Please see my attached comments on pending permit WQ0005462000 and Docket Number CWA-06-2024-1768 for SpaceX deluge operations in Cameron County. Thank you for your consideration of these critical issues.

1. Starbase is polluting with Process Water, which TCEQ has incorrectly characterized as "Non-Process" water.

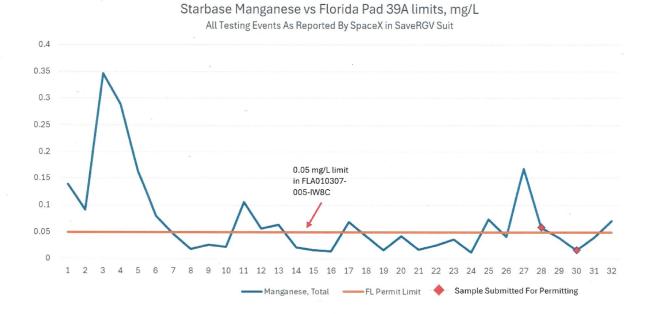
As noted in the Permit Statement of basis, TCEQ consciously decided to forego completing any TBEL analysis "Based on the presumption of the quality of the other contributing waste streams being consistent with the quality of stormwater runoff of the facility."

This is patently false. SpaceX has collected numerous samples that clearly indicate pad runoff water is NOT consistent with existing stormwater discharges. They just didn't send these samples to TCEQ, and TCEQ did not ask for them.

Starbase Total Dissolved Solids (TDS) vs Florida Pad 39A limits, mg/L All Testing Events As Reported By SpaceX in SaveRGV Suit

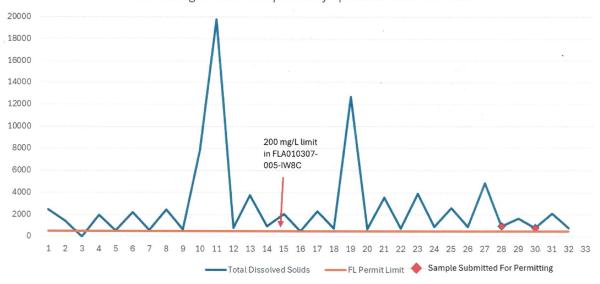
Using data submitted to federal court (case 1:24-cv-00148, filed 10/11/2024) collected by SpaceX itself, the company cannot in good faith represent that the samples collected for permitting are representative of site wide discharges. I have charted some of these (with TCEQ and SpaceX's own NPDES limits from pad 39A in Florida as a reference):

These charts show a clear and disturbing trend. SpaceX submitted samples that show concentrations that are well below the long-term averages SpaceX itself collected. The company then fraudulently claims that the samples provided were representative of all the facility wastewater AND stormwater regulated under its MSGP authorization, despite the fact that many of these samples showed criteria pollutant levels at many times (often thousands of times) higher. This is false and the representation makes the entire analysis performed by TCEQ pointless, illegal and moot.

Launch 5 (10/13/24) looked like this:

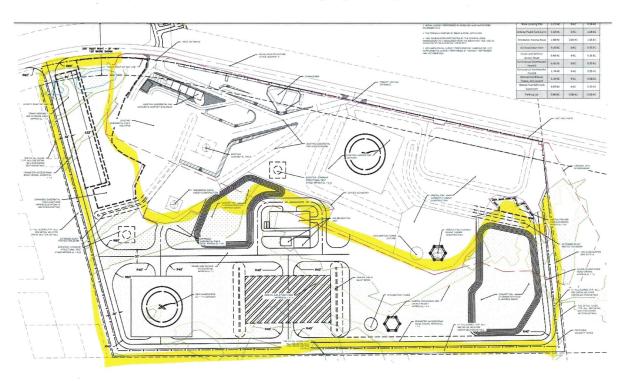
EPA has already cited SpaceX for violating the law for discharging liquid oxygen into the wetland in June 2022, but a close look at the videos from last week's launch make it clear that cryogenic fluids are gushing out into the wetlands and pooling.

This is a huge departure from previous launches, where there was residual vapor but not extensive pooling.

While ambient conditions can and do impact how rapidly cryogenic liquids volatilize, this is irrelevant because hazardous liquid discharges to wetlands are prohibited by 30 TAC 327 and 40 CFR 302.4.

SpaceX must install blow down/venting containment for environmental protection AND to comply with State Fire code.

SAMPLE CROSS REFERENCE

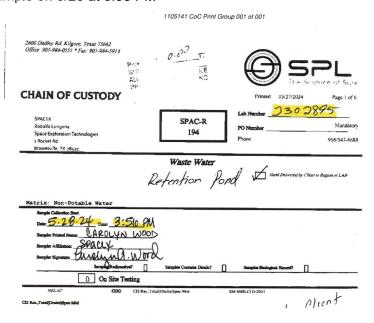
In the Lab Report from SPL, sample 2302895 is listed as having been collected at 6:30 PM on 5/29:

However, the Chain of Custody form indicates that SpaceX employee Carolyn Wood collected the sample on 5/28 at 3:56 PM

Furthermore, the sample was handed over to FedEx at 5:30 PM on 5/29, AN HOUR BEFORE the sample was listed as collected.

On top of this, SPL never signed the CoC for receipt. This sample is functionally worthless and must tossed. Further, this demands an investigation given evidence presented above that SpaceX is selectively submitting samples to TCEQ.
